Summary of Items Discussed in APSEC Discussion Forum (ADF) 2/2026 on 8 May 2026

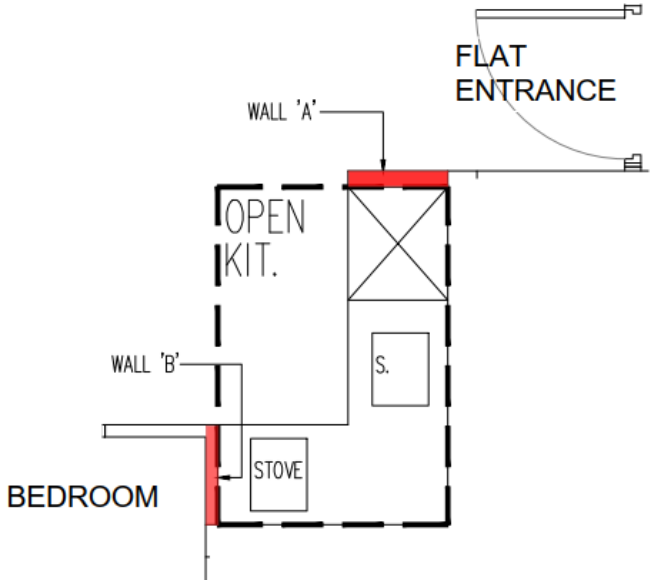
2.	<u>Full Height Fire Rated Wall of Open Kitchen</u> Clause C13.4(d) of the Code of Practice for Fire Safety in Buildings 2011 (2024 Edition) (FS Code) requires a full height wall having a fire resistance rating (FRR) of not less than -/30/30 should be provided adjacent to the <u>flat exit door</u> (Wall "A" in diagram below). Would BD clarify if the FRR wall adjacent to the bedroom (Wall "B" in the	BD drew members' attention to Item 18 of ADF 1/2024 held on 23 February 2024 and advised that the purpose of the full height fire rated wall required for open kitchen under Clause C13.4(d) of the FS Code was to shield the occupants from radiant heat of stove fires and allow the necessary pause of occupants to open the exit door (and gate, if any).

diagram below) is required under Clause C13.4(d).  The diagram shows a floor plan of a flat. It includes a bedroom, an open kitchen (labeled 'OPEN KIT.'), a bathroom (labeled 'S.'), and a staircase. Wall 'A' is the top wall of the kitchen area, and Wall 'B' is the left wall of the bedroom. The flat entrance is at the top right. A red line indicates the required handrail path along the walls and around the stairs.	As Wall “B” in the diagram was not situated adjacent to the exit door of the flat, it was not subject to requirements of Clause C13.4(d) of the FS Code.

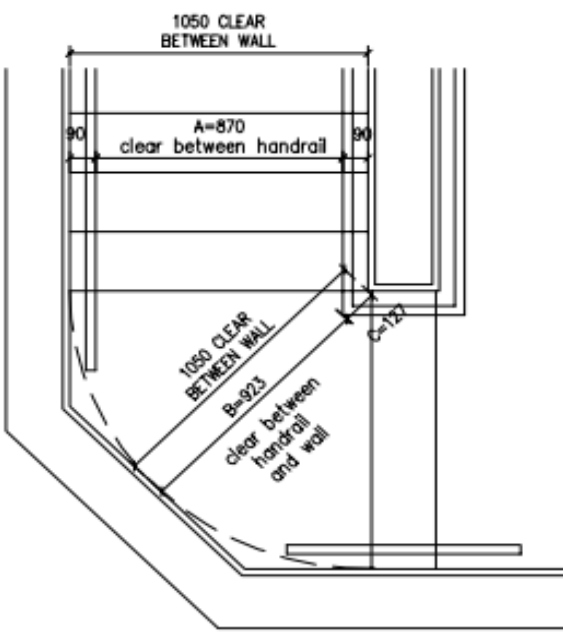
3.	<u>Projection of Handrail at Corner</u> Clause B14.6(b) of the FS Code requires that a handrail within the required staircase should not project so as to reduce the clear width of the required staircase by more than 90mm, for each handrail. However, due to the geometry at the corner, the projection would likely exceed 90mm. As illustrated in the diagram below of a staircase with an outer corner splayed, taking into account the clear width between the handrails at the straight flight (“A”) and at the landing (“B”), would BD consider accepting the handrail projection at the corner (“C”), which exceeds 90mm?	BD advised that according to Note 3 of Table B2 of the FS Code, the width of a required staircase and staircase landing should be measured between the finished surfaces of walls or of the inner sides of any balustrade and should not be decreased by the introduction of any projections other than handrails the projection of which should not exceed 90mm. Hence, the proposed layout as illustrated in the diagram was considered not acceptable.

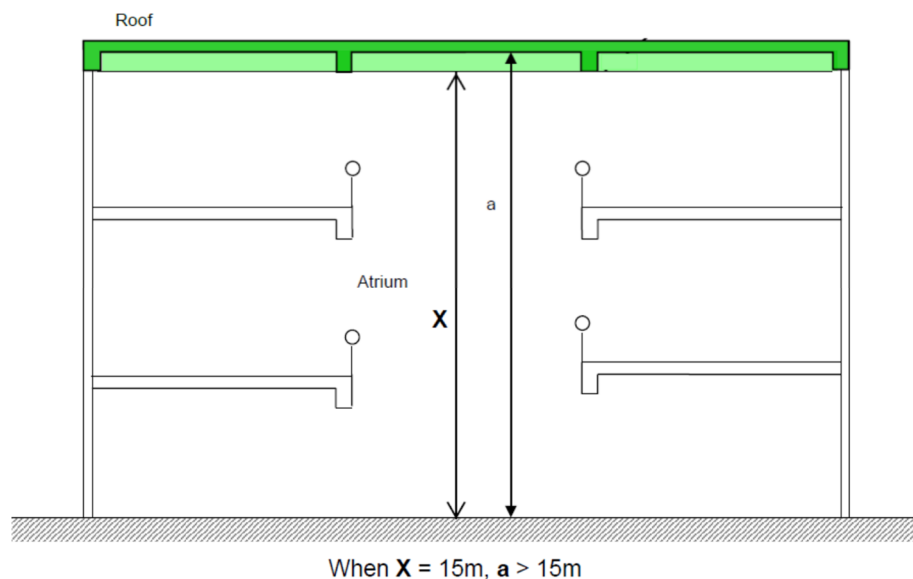
Referring to the diagram below, the dimension “X” shall not exceed 15m. When “X” is 15m, the dimension “a” could be more than 15m. Would BD please confirm if our understanding is correct.

Items raised by AAP	
11.	<u>Height of Atrium</u> According to Clause C10.3(c) of the FS Code, <i>“the maximum height from lowest connected floor to the underside of the lowest structural member of the ceiling of the upper-most connected floor should not exceed 15m”</i>.	BD confirmed AAP’s understanding was correct.

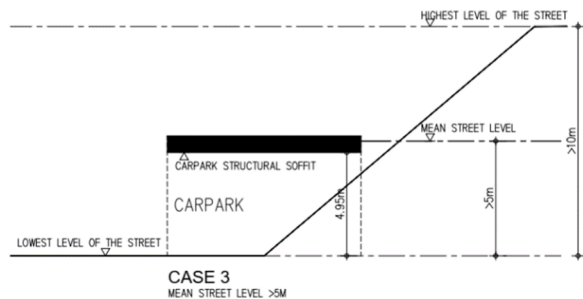
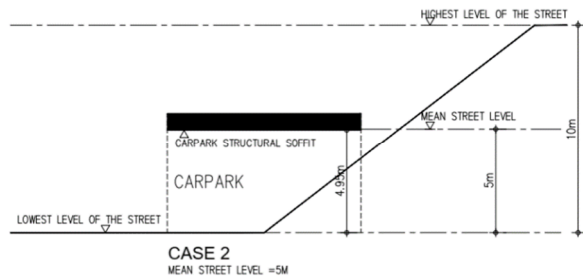
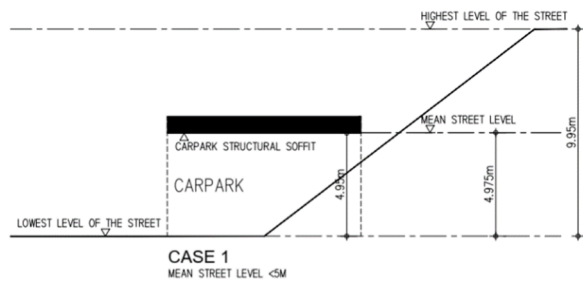
For a car park with structural ceiling soffit at 4.95m above the lowest level of the street, we have the opinions that all the following cases can be accepted as underground car parks:

BD advised that under paragraph 3(a) of Appendix C to PNAP APP-2, Case 3 could not be accepted as underground car park for the purpose of GFA concession as its mean street level was more than 5m above the lowest level of the street.

Nevertheless, favourable consideration might be given if there were site constraints that affect the design and location of the car parking floors,

provided that the topmost car park floor is semi-sunken and follows the slope profile of the site and adjoining land, etc, according to paragraph 3(d) of Appendix C to PNAP APP-2.

In passing, BD reminded that excessive headroom of car parks should be justified for Building Authority (BA)'s consideration upon general building plan (GBP) submission.

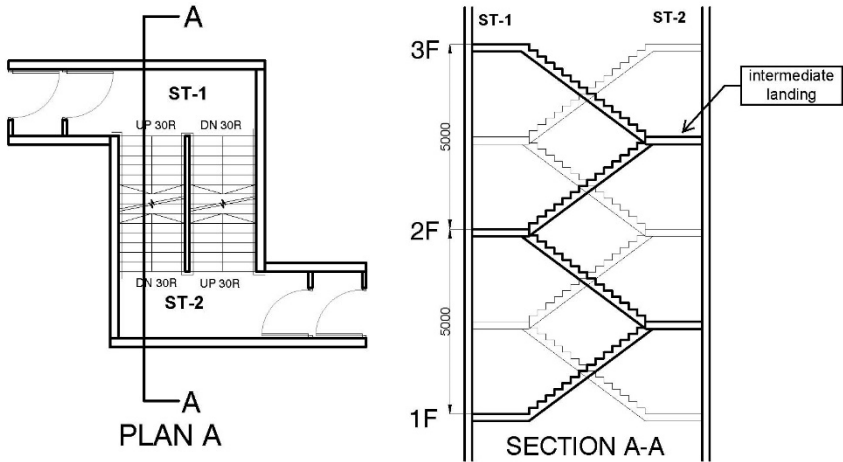
AOB Items	
18.	<u>Discharge Value of Scissors Staircase</u> (Item raised by AAP) According to Clause B12.7 of the FS Code, “<i>the discharge value of a scissors staircase without any intermediate landing between 2 consecutive floors should be... multiplied by a reduction factor of 0.7</i>”. Our understanding is that the design of the two different scissors staircases under Case 1 and Case 2 as illustrated in the diagrams below both consist of intermediate landing between 2 consecutive floors thus it is not necessary to apply the reduction factor in determining the staircase’s discharge value. Would BD please confirm if our understanding is correct.  The diagrams illustrate two scissors staircase configurations, ST-1 and ST-2, for Case 1. PLAN A (left): A top-down view of the staircase layout. ST-1 is an upper staircase with 'UP 30R' and 'DN 30R' flights. ST-2 is a lower staircase with 'DN 30R' and 'UP 30R' flights. A horizontal line 'A' indicates the location of the section cut. SECTION A-A (right): A vertical cross-section showing the two staircases between floors 1F, 2F, and 3F. ST-1 is the upper staircase and ST-2 is the lower staircase. Both have a flight length of 5000 units. An 'intermediate landing' is shown between the two staircases at the 2F level. <u>Case 1</u>	BD advised that AAP’s understanding was correct.
